Service Bulletin

Bulletin No.: 15-06-01-002K

Subject: Engine Misfire/Tick Noise, Malfunction Indicator Lamp (MIL) Illuminated - DTC P0300 Set

This bulletin has been revised to update the Parts Information section.
Please discard Corporate Bulletin Number 15-06-01-002J.

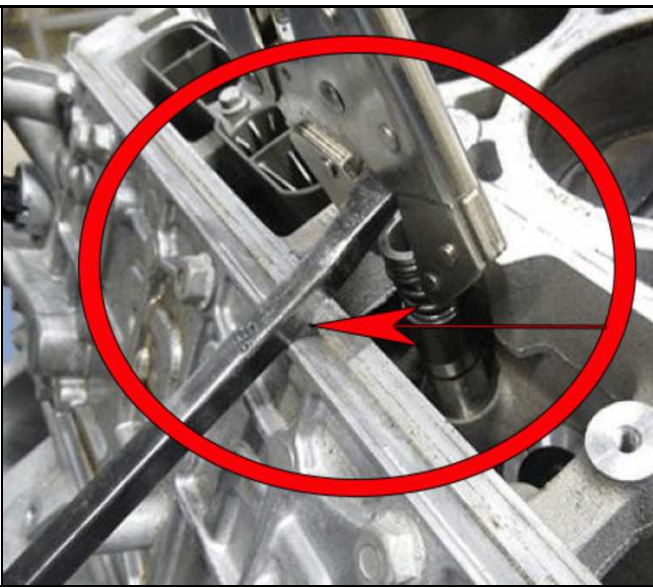
There are two approved processes for removing the lifter when stuck in the bore.

1. Use vice grips with a slide hammer.

Note: Be sure **NOT** to pry on the sealing surface of the block, as shown in the illustration above.

2. Use vice grips with a small pry bar.

Typically, one of the above approved processes will remove the lifter that is stuck in the bore. If not, the engine will need to be replaced.

With the lifter removed, be sure to inspect the bore for any damage. Typically, the lifter bores will look good with no indication of damage.
